PLANNING COMMISSION
DATE: 6/30/14
AGENDA ITEM: 5A – BUSINESS ITEM
CASE # 2014-36

ITEM: Village Preserve South - Sketch Plan Review
SUBMITTED BY: Nick Johnson, City Planner
REVIEWED BY: Kyle Klatt, Community Development Director
Jack Griffin, City Engineer
Ann Pung-Terwedo, Washington County

SKETCH PLAN 06-16-14
VILLAGE PRESERVE SOUTH
(Parcel E, Holiday Parcel)
GWSA LAND DEVELOPMENT

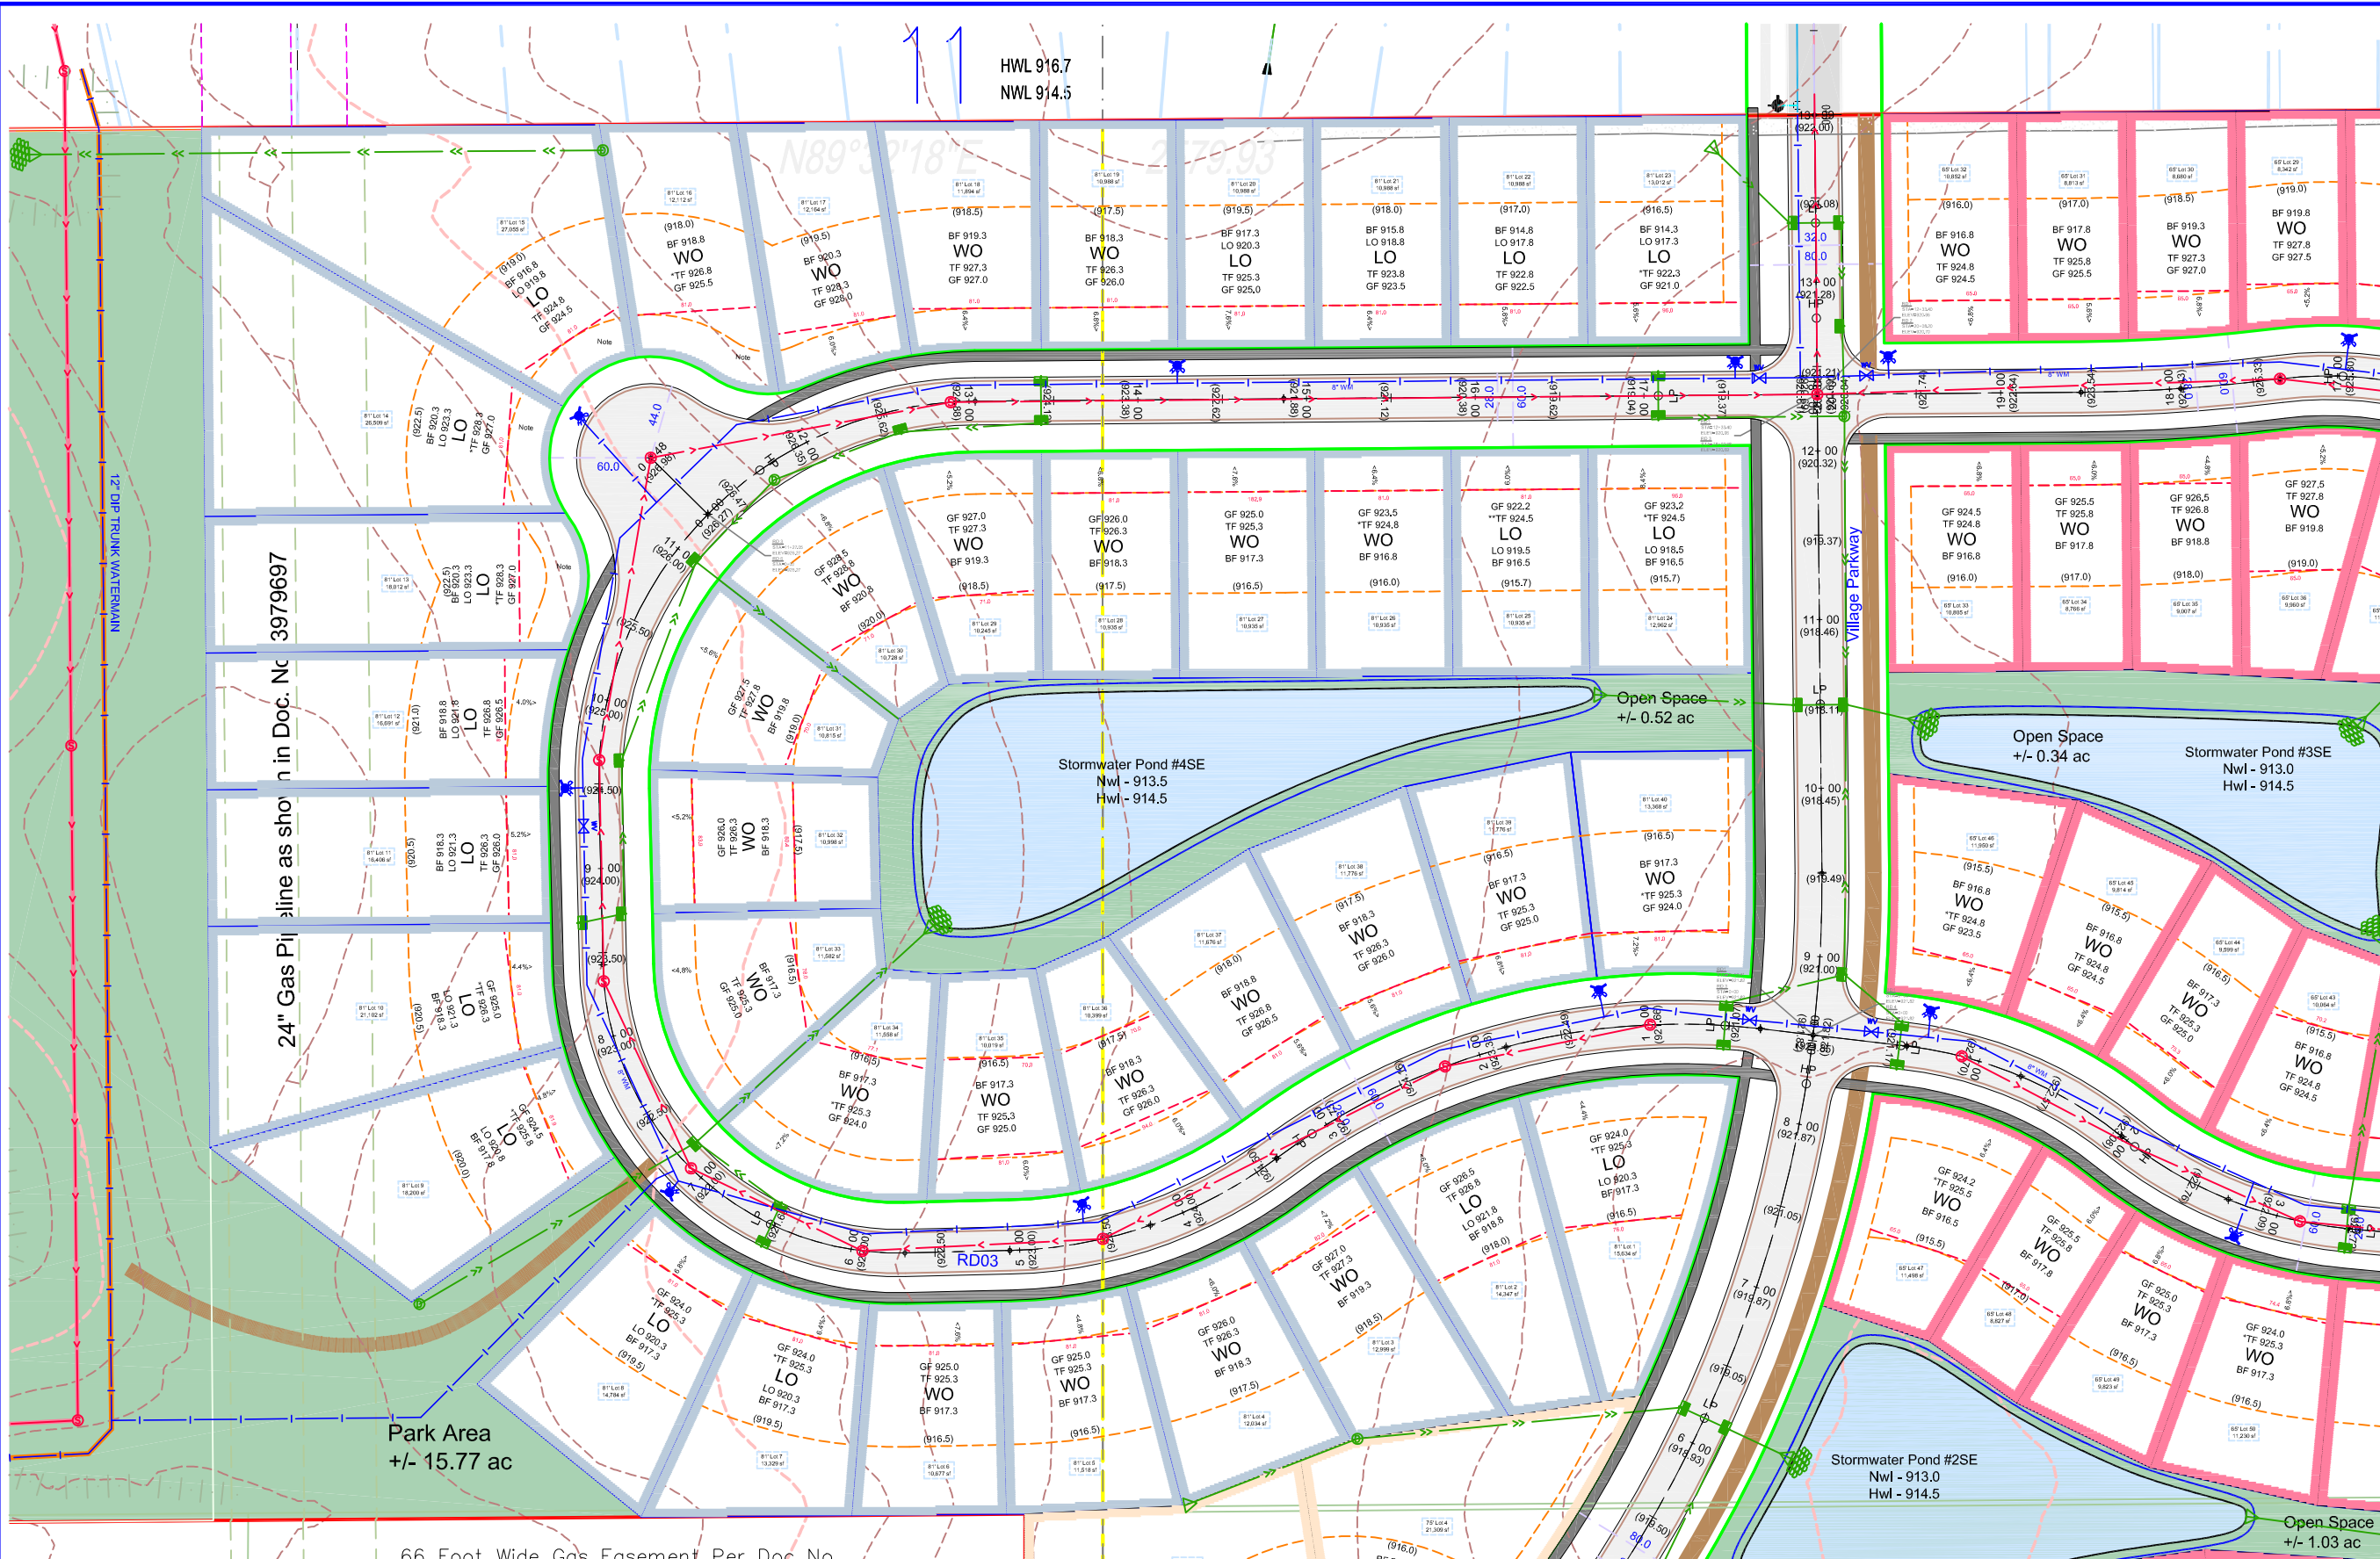
- ***Land Use:*** The proposed Sketch Plan does not currently conform to the City's Land Use Plan, as the Holliday parcel is currently guided for Rural Area Development (RAD). The applicant has submitted a Comprehensive Plan Amendment request to change the land use guidance of the property from RAD to V-LDR. To consider this request, a public hearing will be held on the June 30th meeting in advance of the review of the Sketch Plan. This request is chiefly related to the need to achieve access to 30th Street through the Holliday parcel via the planned Village Parkway minor collector road. As the proposed minor collector road is critical to distributing projected traffic associated with growth on the eastern side of the Village, Staff finds strong merit in the request and is recommending approval of the Comprehensive Plan Amendment.

- **Density:** The submitted Sketch Plan includes calculations for both the gross and net density figures, and the provided net density calculation of 2.09 units per acre falls within the allowed range of the Village Urban Low Density land use category (1.5 - 2.49 units per acre).

- **Parks and Open Space.** As part of the Village Preserve South subdivision, the applicants are proposing to dedicate +/- 15.77 acres of land adjacent to Reid Park. This dedication would provide a significant expansion of Reid Park, allowing for additional recreational uses or activities. While reviewing a separate development application from GWSA Land Development, LLC for a parcel in the northern portion of the Village Planning Area, the Park Commission reviewed the proposal to expand Reid Park on March 17, 2014 and were supportive of the proposal.

- **Sidewalks and Trails.** The submitted Sketch Plan includes sidewalks on one side of all local residential streets, which is consistent with City standards for single family residential subdivisions. In addition, the Sketch Plan includes two proposed local trails. The first trail

- **Private Utilities.** It should be noted that a Northern Natural Gas pipeline is located on the western edge of the proposed single family subdivision. The easement in which the pipeline is located does impact a portion of the rear yards of 7 residential lots on the western edge of the development. Any work within these areas will require the permission of the easement-holder.

- **Streets.** The Sketch Plan includes residential streets with 60' rights-of-way and 28' streets, back of curb to back of curb. This design is consistent with the City standard for local residential streets, and would allow for parking on both sides of the street while maintaining safe traffic circulation and emergency vehicle access. It should be noted that no longer cul-de-sacs are being proposed as part of the subdivision. However, a small cul-de-sac with 4 larger residential lots is planned in the southern portion of the subdivision directly off the minor collector road. Given that Village Parkway is residential collector with low design speed (35mph), it is likely that the design will work. However, staff would like to study the design of the intersection at the cul-de-sac in greater detail. In terms of the design of the Village Parkway minor collector road, the proposed design shown in the Sketch Plan is consistent with the City's typical section (Attachment #5).

- **Access.** The applicants are proposing to have the main access for the development come off of 30th Street via Village Parkway. The design and location of the proposed minor collector road is consistent with the City's Transportation Plan. The County has reviewed the Sketch

SKETCH PLAN 06-16-14
VILLAGE PRESERVE SOUTH
 (Parcel E, Holliday Parcel)
GWSA LAND DEVELOPMENT

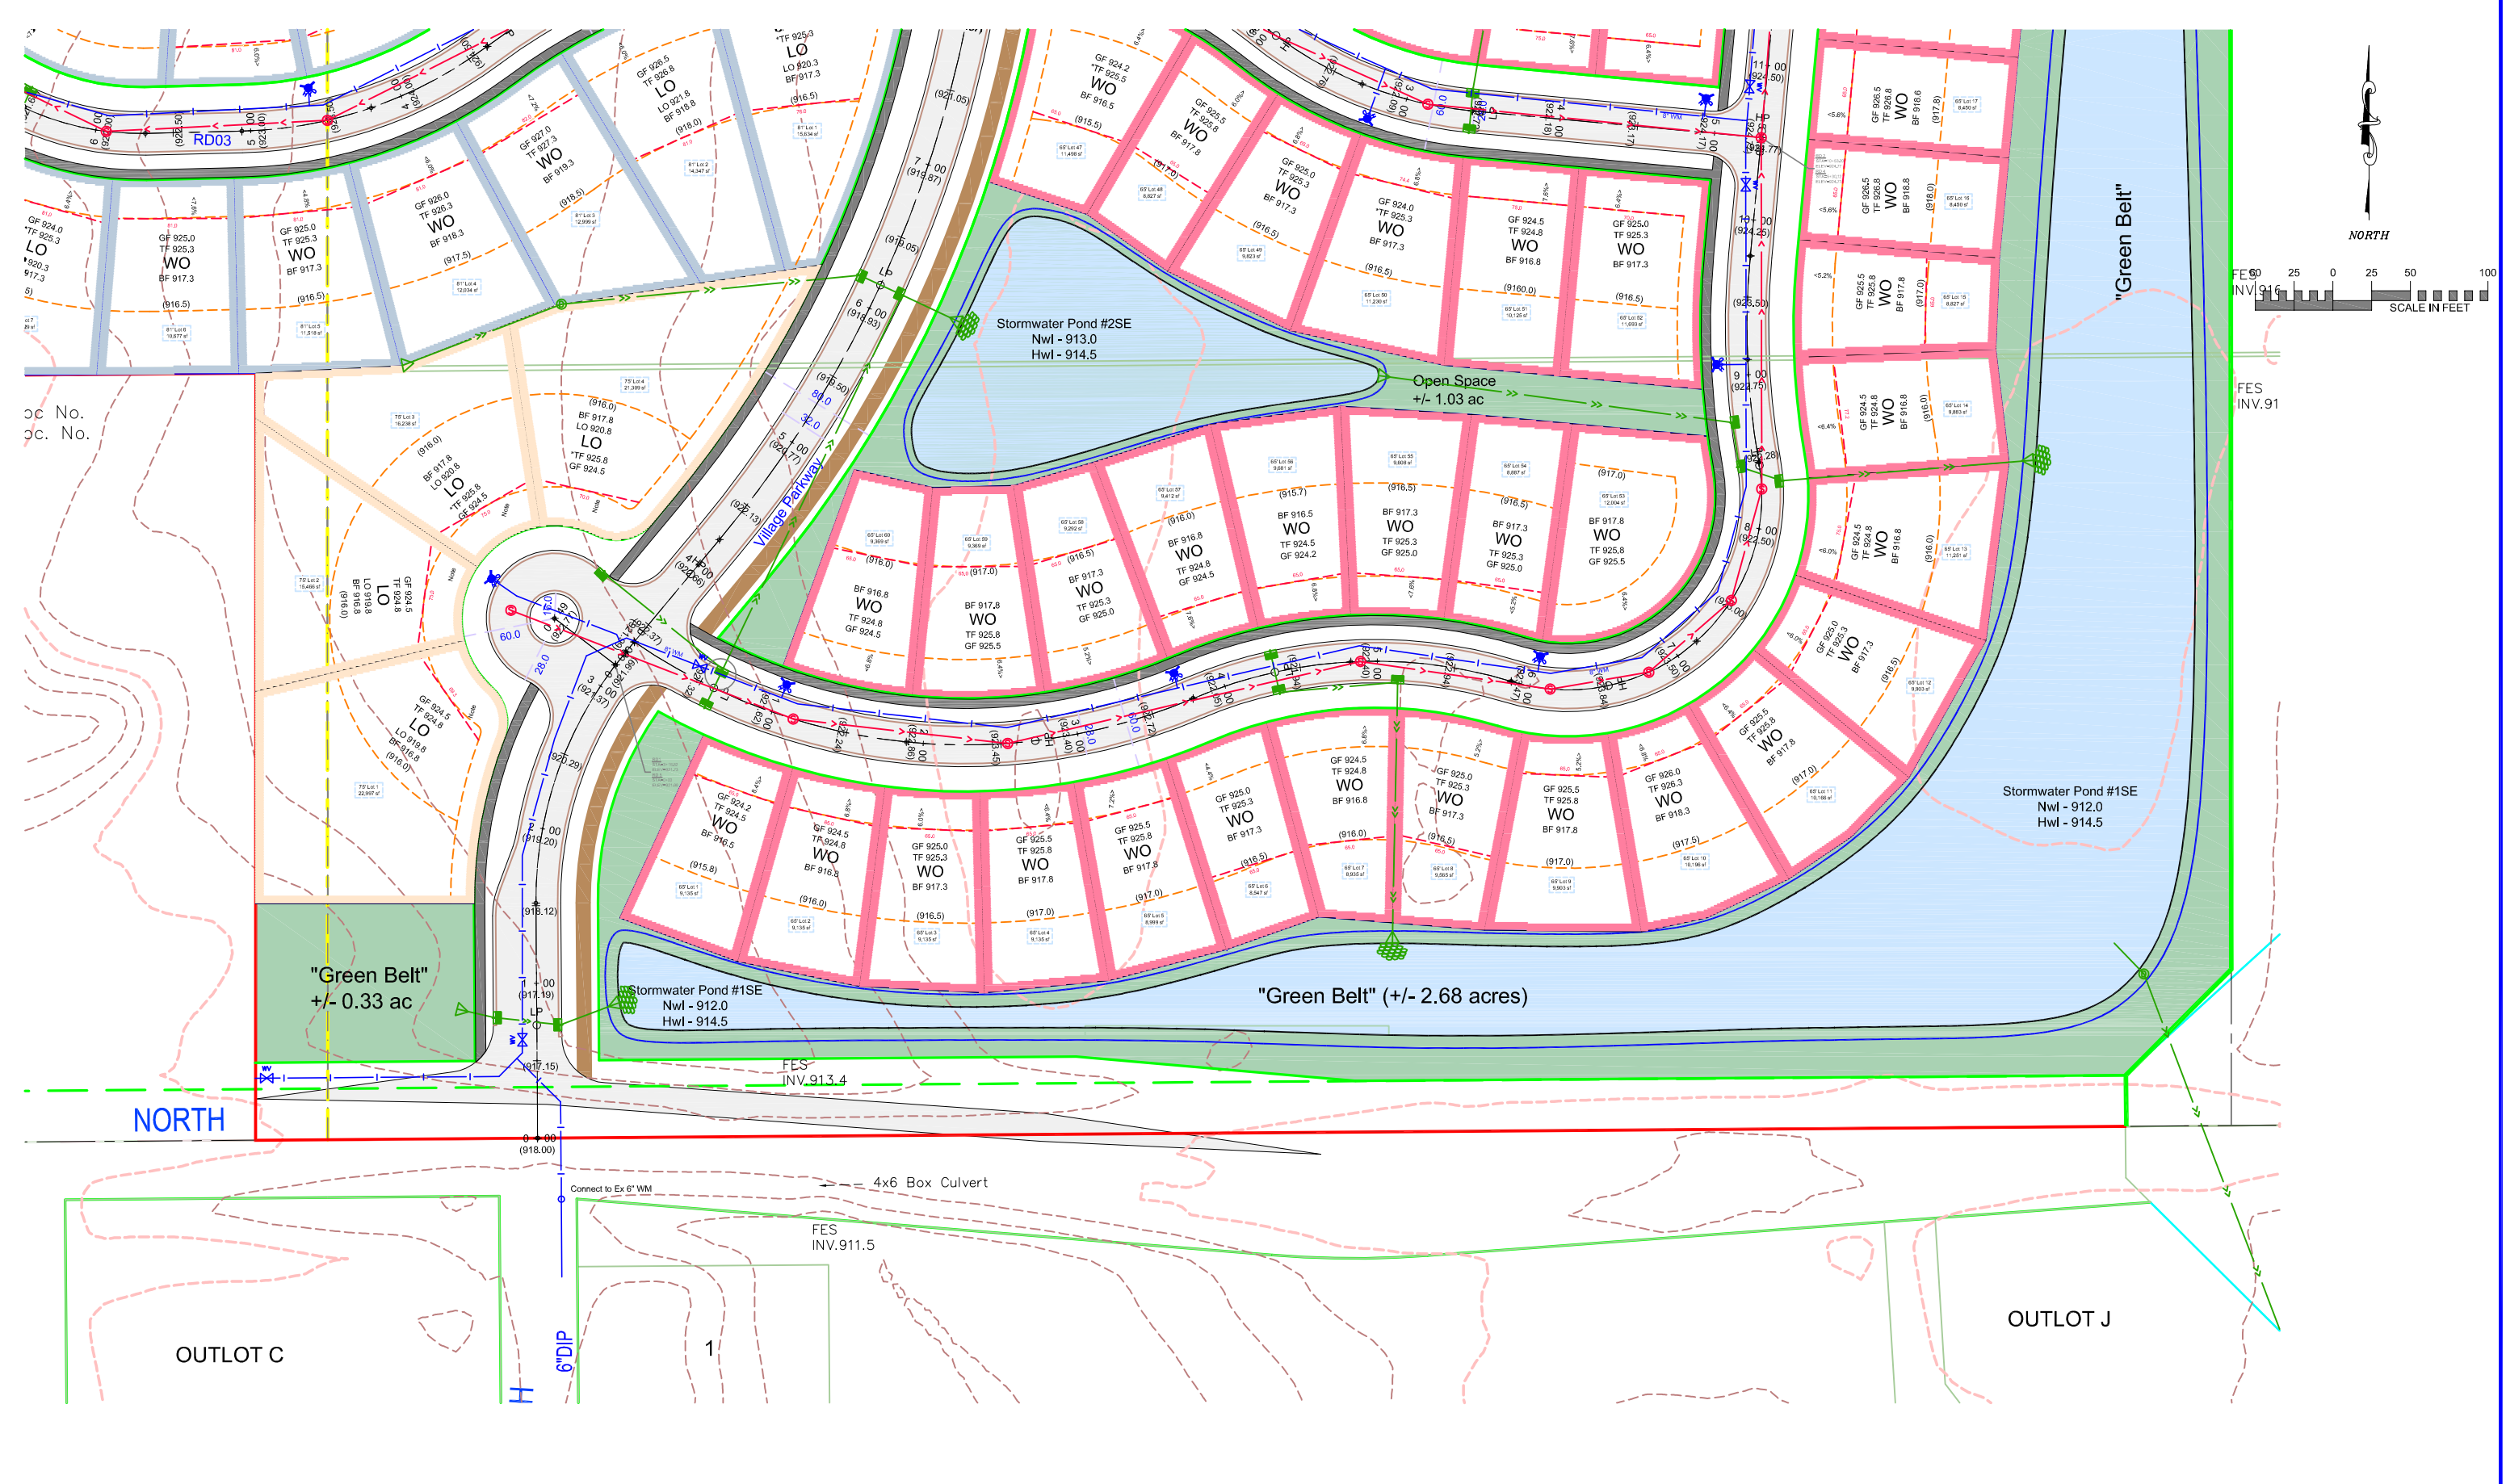
- The general drainage system should mimic the natural topography of the site in order to ensure a drainage system that provides positive storm water drainage across the development. The proposed drainage plan appears to create three landlocked storm water ponds. Overland emergency overflows or outlets will need to be incorporated as part of the site plan.

- The proposed site plan does not appear to provide infiltration basins as required to meet State and watershed infiltration requirements.
- The storm sewer system shall be designed to maintain the City standard **minimum** pipe cover of 3.5 feet. Drain tile is required as part of the City standard street section at all localized low points in the street. Drain tile considerations may impact the storm sewer design and depth requirements at low points.

- All streets must be designed to meet the City's Engineering Design Standards including R/W width, street width and cul-de-sac radii. The plans appear to substantially conform to this requirement.
- The cul-de-sac intersecting Village Parkway near 30th Street appears to provide driveway access to the four adjacent properties such that direct access is not to Village Parkway. As the development progresses through the process staff will continue to review the geometrics for this intersection.
